**Standard Number:** UL 1778 / CSA C22.2 No 107.3  
**Standard Name:** Uninterruptible Power Systems  
**Standard Edition and Issue Date:** 5<sup>th</sup> / 3<sup>rd</sup> Edition Dated June 13, 2014  
**Date of Revision:** October 12, 2017  
**Date of Previous Revision of Standard:** August 7, 2015

## EFFECTIVE DATE OF NEW/REVISED REQUIREMENTS

## IMPACT, OVERVIEW, AND ACTION REQUIRED

**Figure NNN.2 – Test setup and port location**

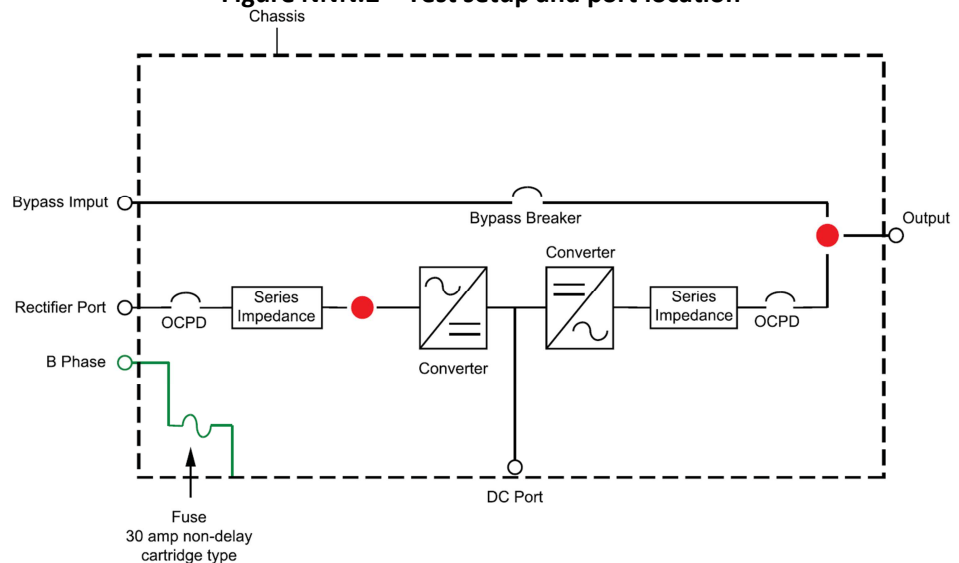
1.5.107		Capacitors or EMI filters connected across the AC MAINS SUPPLY shall comply with the requirements for across-the-line capacitors in UL 1414 <u>60384-14</u> or CSA E60384-14, UL 810 or CSA C22.2 No. 190, and UL 1283 or CSA C22.2 No. 8, or the test specified in 5.2.101 of this Standard.
Annex NNN	Info	<b>Short-circuit withstand rating</b>
NNN.3		<b>Test procedure</b>
NNN.3.1		<b>General application</b>
		<b>New clause added;</b>
		Testing port requirements
NNN.3.1.3		A UPS rated for multiple input and output voltages shall be tested at the highest rated input voltages provided that applicable interrupting components have been evaluated to interrupt the prospective test current at the highest rated input voltage. For a UPS with multiple rated withstand markings, the port indicated in Figure NNN.2 shall be tested. The following two tests are required at each port being marked on the UPS with a withstand rating: a) Short-circuit making capacity "Closing test"; and b) Short-circuit capacity "Withstand test".

**New figure added;**
